Communication from Public

Council File No: 21-0141

This agenda to be seen by the PLUM Committee on June 15, has two projects on Venice Blvd in CD11 where the proposed underground parking of the projects go all the way to the property lines making it impossible to put trees "in the ground" as opposed to in planter boxes. Trees in planter boxes will not thrive and will most likely die from lack of water, and nutrients from the soil.

11961 Venice Blvd

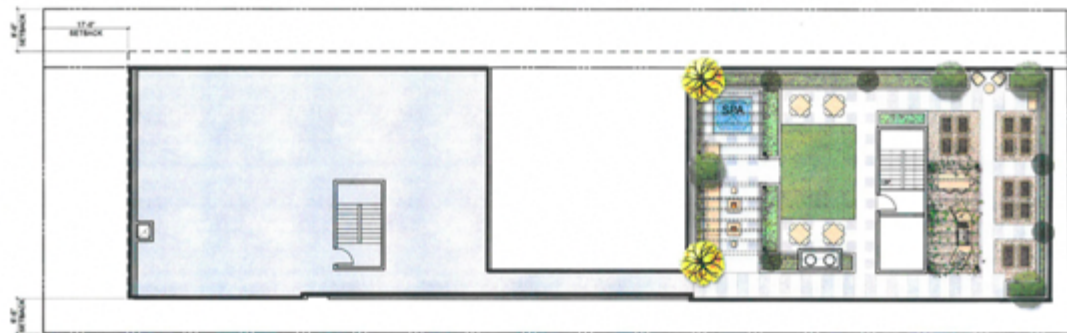
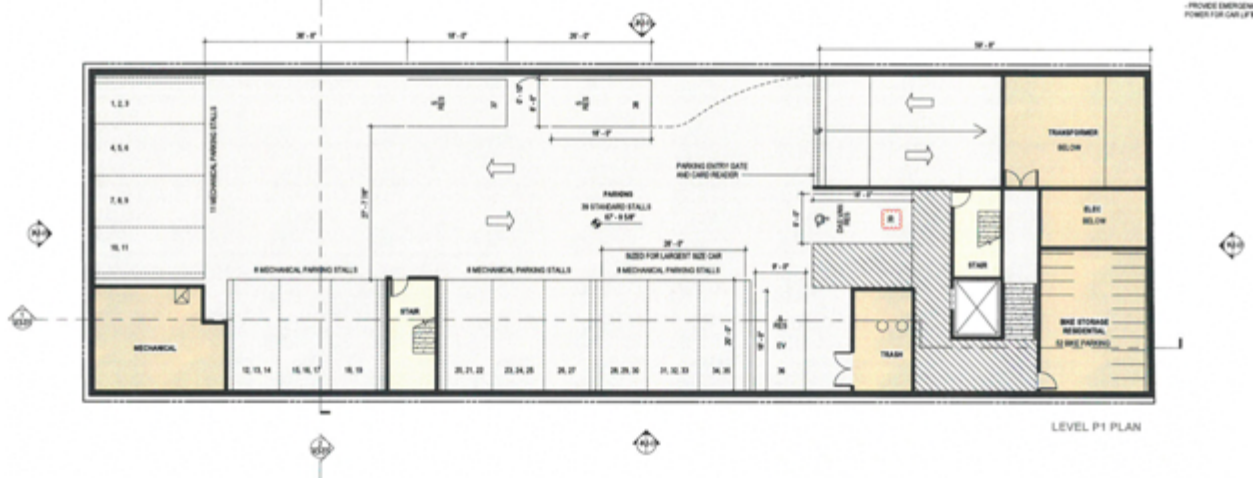
1. Issue #1 The project proponents will remove one large street tree. Narrowing the driveway might save a tree. The driveway here is larger than required. As you can see Venice Blvd has a wonderful mature tree canopy. Removing one will make a significant gap in the canopy.
2. Issue #2 They have left no room on site for any trees in the ground due to the size of the parking garage. The garage has an aisle width that is greater than necessary. Decreasing the aisle width would allow for a narrow setback which could accommodate trees or vegetation in the ground. Additionally if the mechanical room in the back could be relocated, they could accommodate a tree in the ground in the rear corner making the dog run much more dog friendly by providing some landscaping.
3. Issue # 3 They meet their tree requirements in planter boxes on the roof. 1' planter will not support trees.

1600 Venice Blvd.

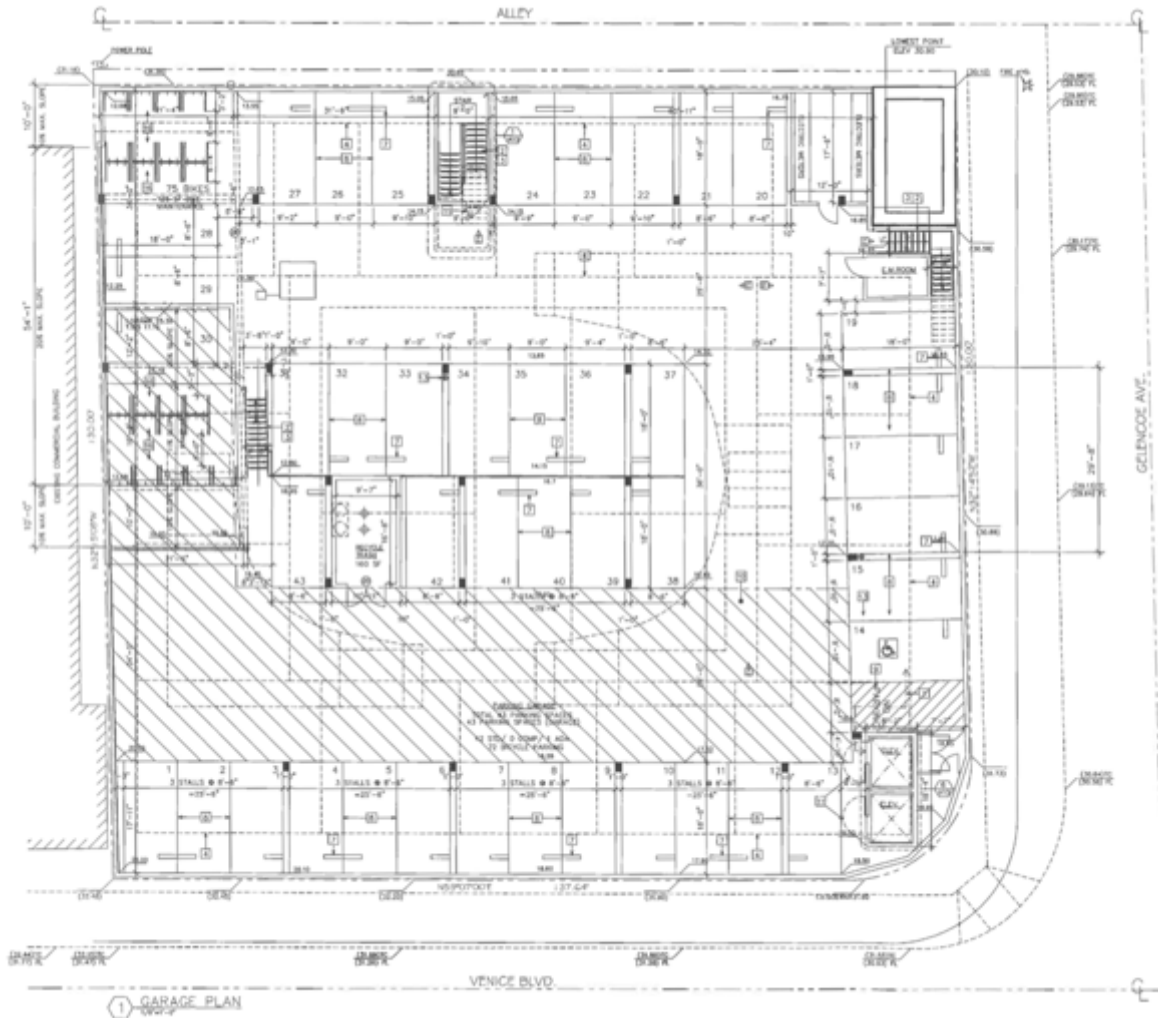
Issue #1 There is no room on site for trees in the ground. The parking garage aisle is bigger than required at 28'. If they made the aisles narrower, they would have some available side yard for trees in the ground.

Issue #2 While they haven't yet requested tree removals, this project goes all the way up to the property lines. There are fern pine trees consistent with the planting theme for Venice Blvd west of the 405 freeway. It should be made clear to the developer that they will not in the future be allowed to request the removal of these street trees and that street tree protections must be installed.

Issue #3 The required LID (low impact development) BMP's of planter boxes in the yard setback prevents the project from incorporating any trees in the ground in the one location where they may occur on site. a different LID solution should be provided so that the building could be properly landscaped.

Issue #4 Required tree on site and the landscaping plans are unprofessional. The lack of care for the residents should not be encouraged. Additionally the drawings are difficult for a layman to read. This project is so badly designed they don't want you to understand what it will look like. The interior units have a view into a narrow courtyard that has insignificant landscaping. If the courtyard were a little bigger and the courtyard went all the way to the ground, the developer could plant significant tall trees that would make the interior units livable.
